LLDP Text¹: Only sections with changes are included.

Clause 79

79.3.2 Power Via MDI TLV

Figure 79–3—Power Via MDI TLV format

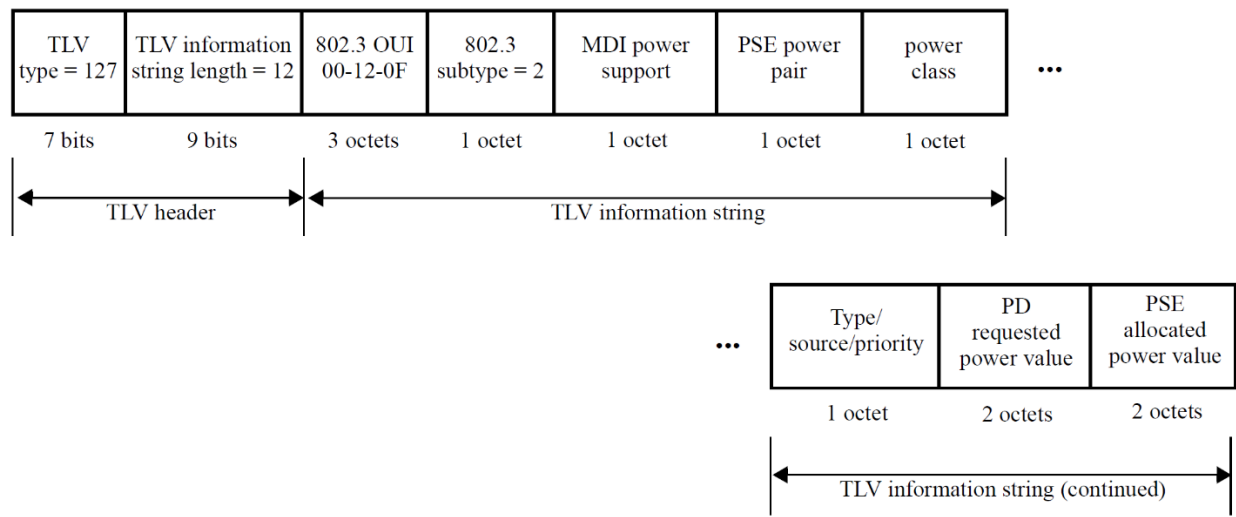
Restore Figure 79-3 from 802.3-2012, change caption to “Power via MDI TLV format for Type 1 and Type 2”

Figure 79-3a—Power Via MDI TLV format for Type 3 and Type 4

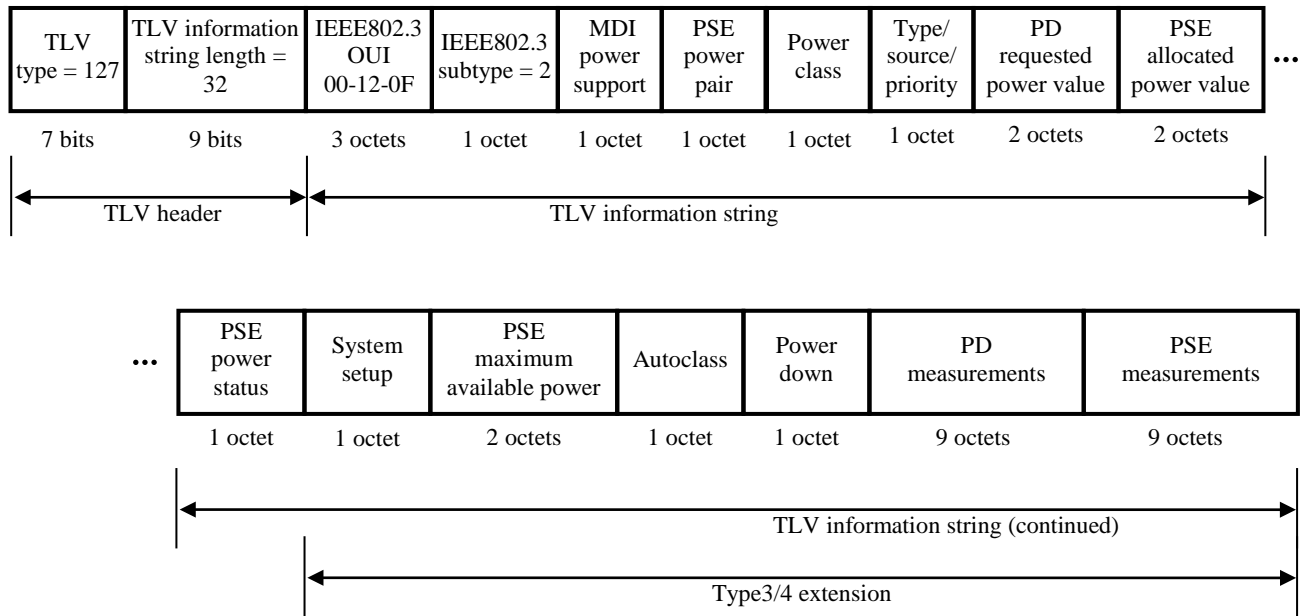
To support also long MDI TLVs a second frame size is defined as shown in Figure 79–3a
